### Ephesus/Fordham Form District Permit Application

Project Name: Fordham Boulevard Apartments  
Property Address: 1312 N. Fordham Boulevard Zip Code: 27514  
Project Description: Demo existing Days Inn and construct new multi-family structure and amenities

Subject: Fordham Blvd. Apartments  
Responses to Round #3 Comments

**C3**  
C1007 POSSIBLE FUTURE ALLEY - TYPICAL SECTION  
VERT. SCALE: 1" = 2' HOR. SCALE: 1" = 4'

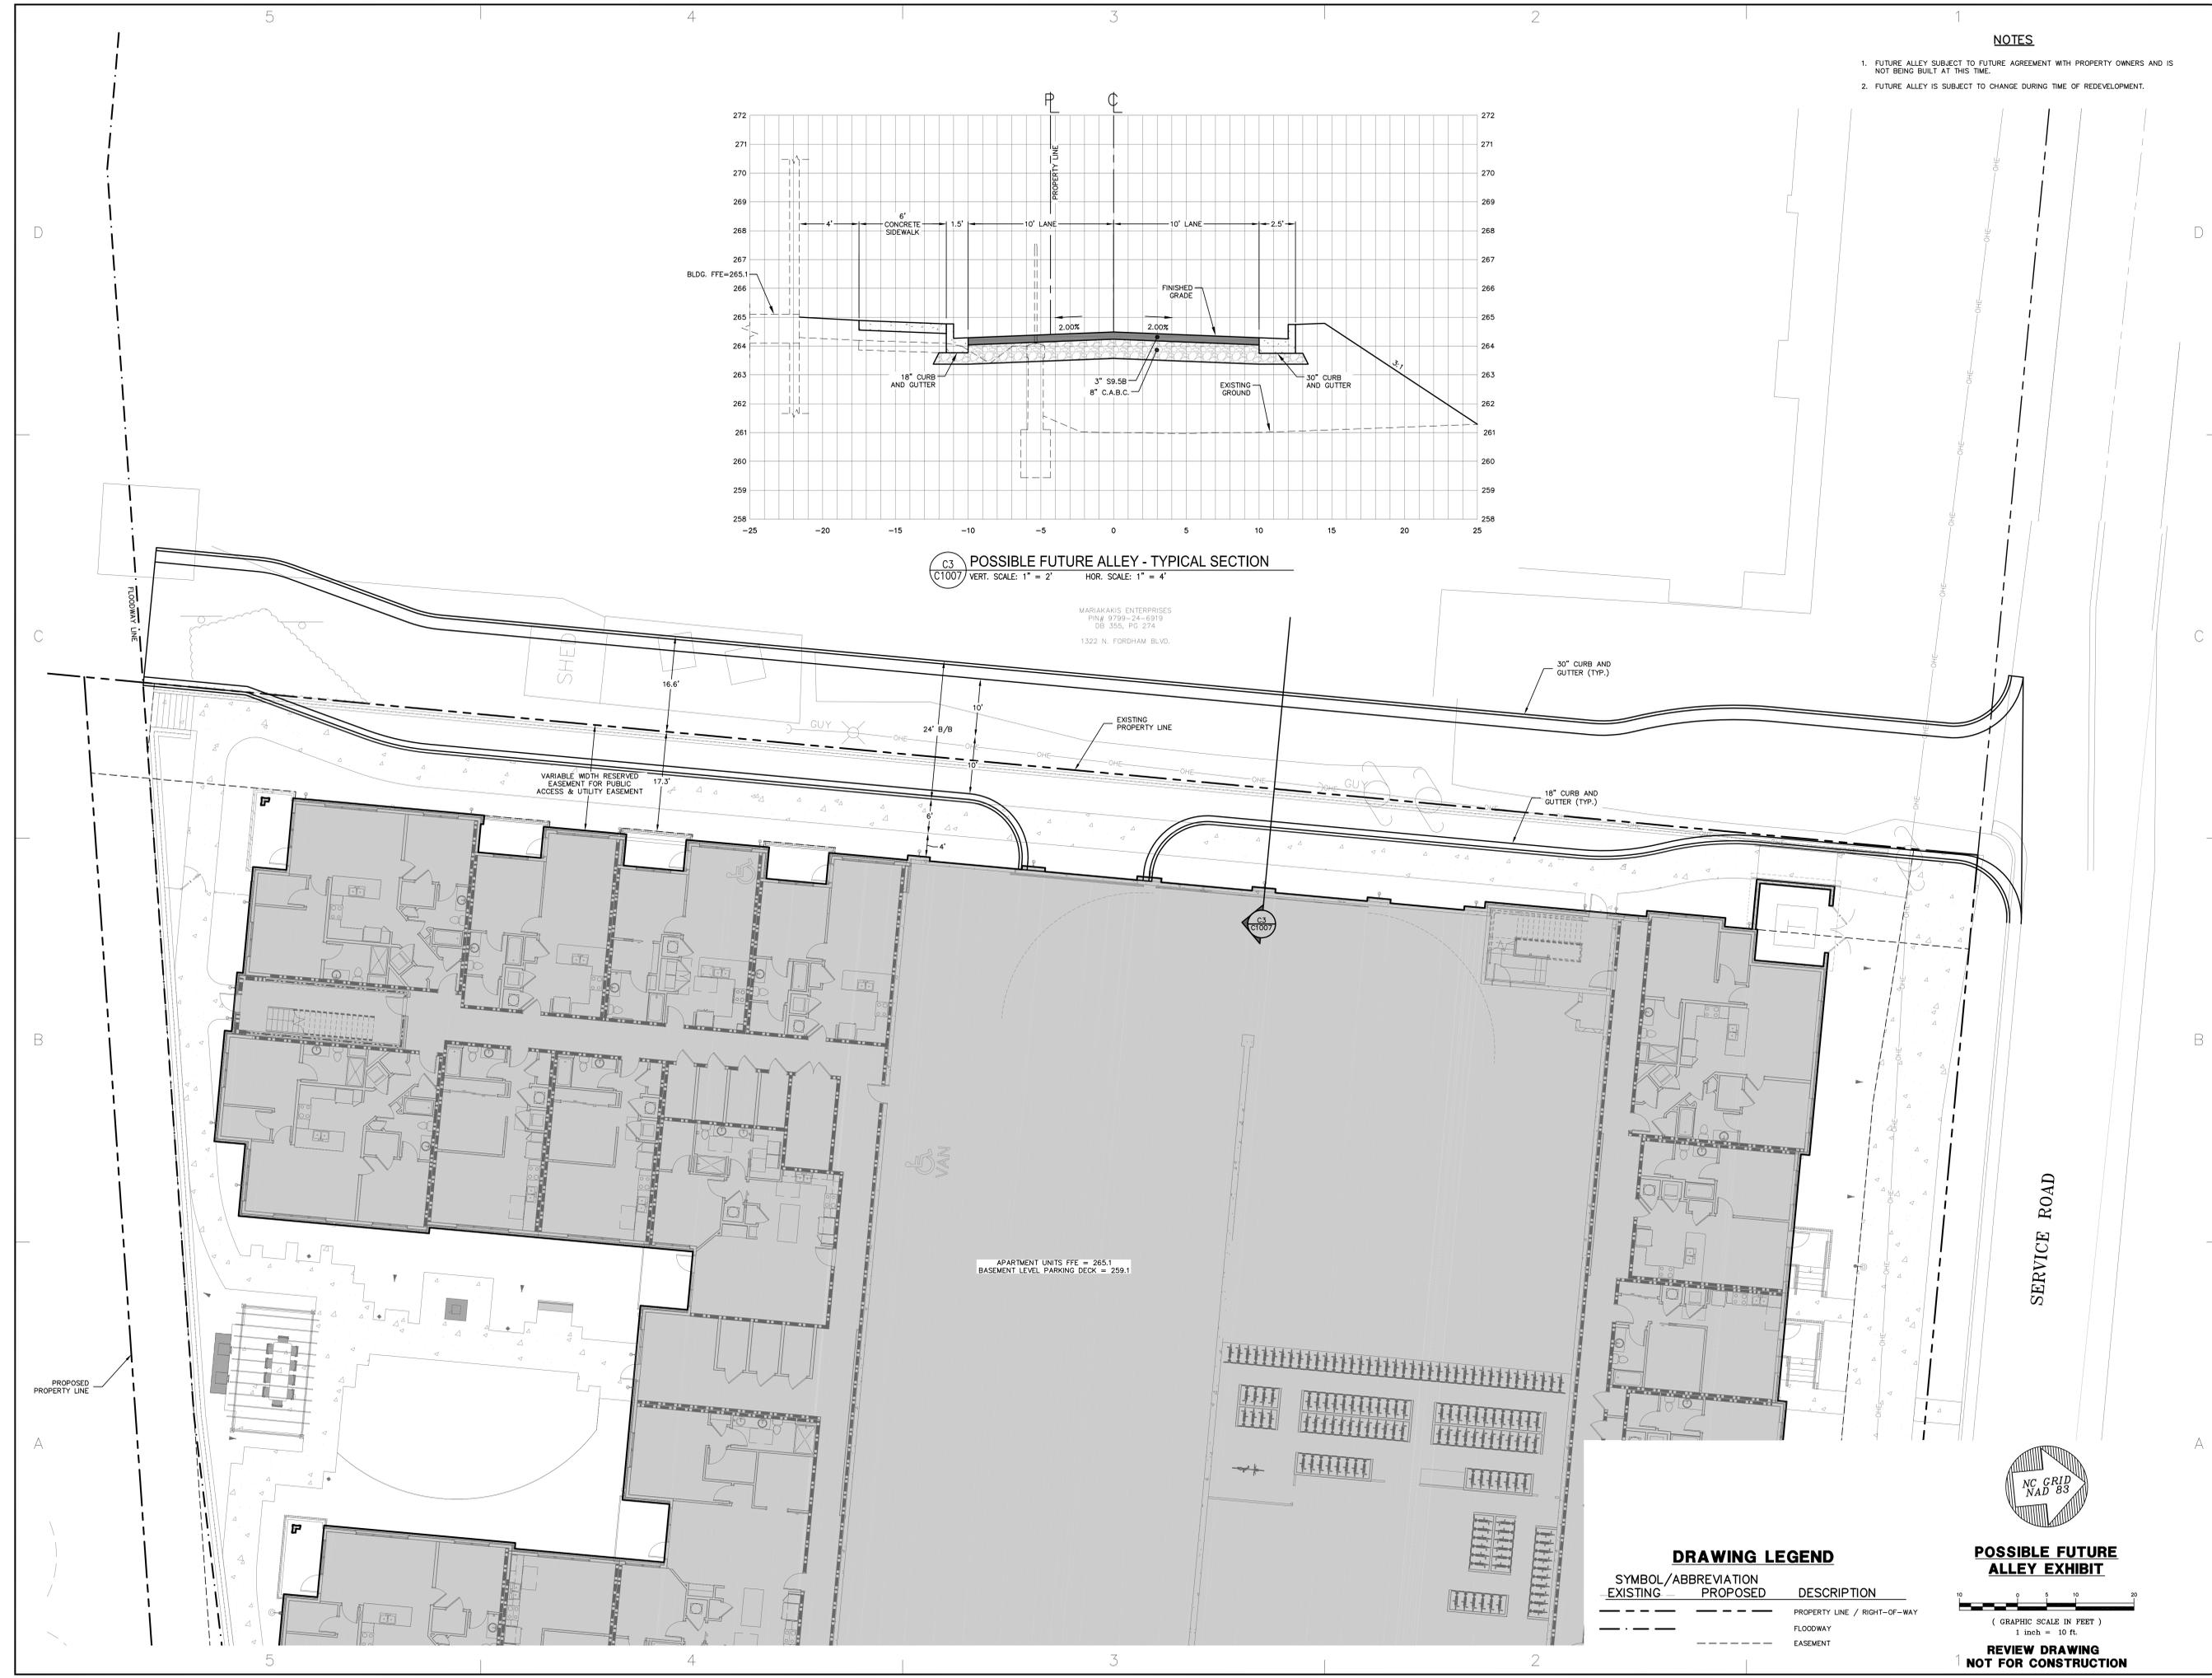
14. In order to meet the minimum Alley Cross section, page D21 of the mobility plan, the following changes are required to the northern "thoroughfare" 1) Relocate planting area between the building and include columnar plantings along parking deck facade to match the rendering shown to the CDC for the parking lot facade approval (sheets A 2.25 and A 2.26) and what I believe was an older version of the landscape plan. 2) Widen sidewalk to six feet. (*Current Development*) UPDATE 11-21-17: I apologize that my previous guidance was not as clear as it could have been– please make the following changes: Minimize planting area width to 4 feet as shown in attached exhibit. If possible, replace plantings with ones that can survive in narrower width and still provide vertical screening of the Parking Garage similar to what was shown to CDC. Return sidewalk to previous location (+/- 4 feet away from building façade), keep six feet width. Remaining area between sidewalk and property line to be used for future alley surface, grass / shrubs in interim. As noted previously - adjustments to the alley cross section to account for the transformer are acceptable. Please see attached exhibit for interim and future alley conditions.

19. My understanding is that we need a cost estimate to be submitted, reviewed, and approved ahead of FDP issuance. Please also submit an exhibit showing the future alley condition and cross section.

**Response: The requested changes have been made. Please see sheets C1001 and LP1.00.**

**Response: A cost estimate and an exhibit for the future alley condition is included with this submittal.**
